UNITED STATES  
NUCLEAR REGULATORY COMMISSION  
WASHINGTON, D. C. 20555

SUBJECT: REQUEST FOR ADDITIONAL INFORMATION AND  
INTERIM FINDINGS FOR FERMI 2

Comments on Supplemental Interim Finding Report for Fermi 2

Figure 6. Fermi 2 Plant Emergency Planning Zone (EPZ)

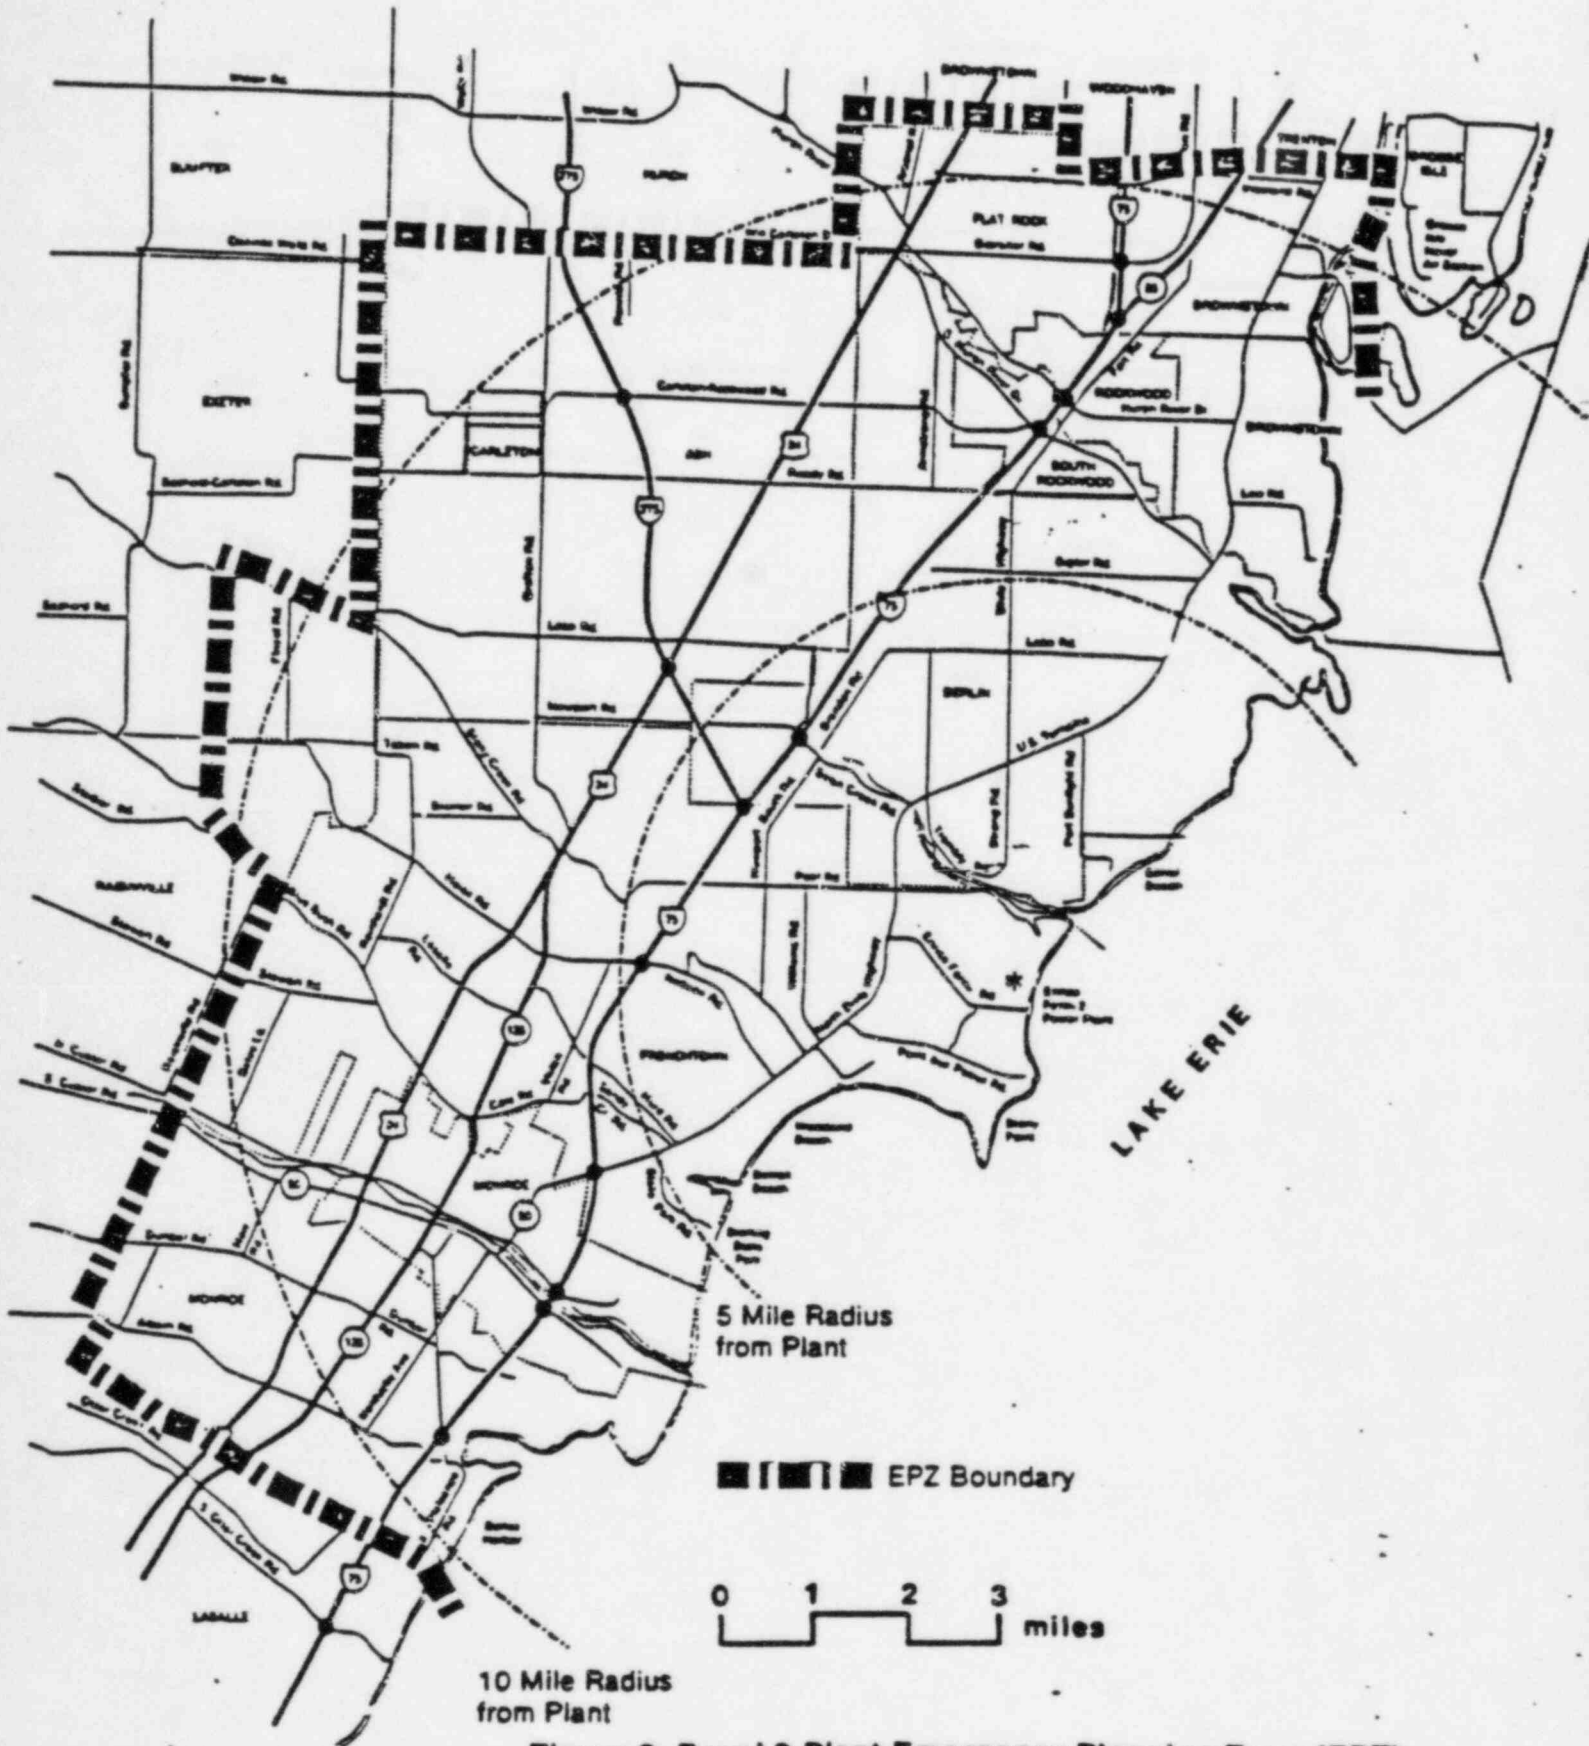
In addition to excluding Canada, the applicant has adjusted the boundaries of the plume exposure EPZ to account for local conditions, primarily local government jurisdictional boundaries, in order to define evacuation sub-areas,

derive evacuation time estimates, and design the prompt alert (siren) system. The plume exposure EPZ with the adjusted boundaries is shown in Figure 6 (copy attached) of the applicant's study of evacuation time estimates.

We note that the plume exposure pathway EPZ is shown in the Monroe County Emergency Operations Plan as a circle exactly ten miles in radius and is defined to consist of all cities, villages, and townships within a ten mile radius of the facility. The Michigan Emergency Preparedness Plan defines the plume EPZ to consist of all townships within a ten mile radius including all cities and villages within those townships but does not illustrate the EPZ in a figure. Neither the local or State plan makes any reference to Essex County, Canada, as being part of the plume exposure pathway EPZ.

The Commission regulations on emergency planning require an evaluation of the size of the EPZ in relation to local conditions. We believe that knowledge of the actual EPZ boundaries is an important consideration for emergency planning purposes. Therefore, we request the assistance of FEMA in evaluating the size and clarifying the boundaries of the proposed plume exposure pathway EPZ for Fermi 2.
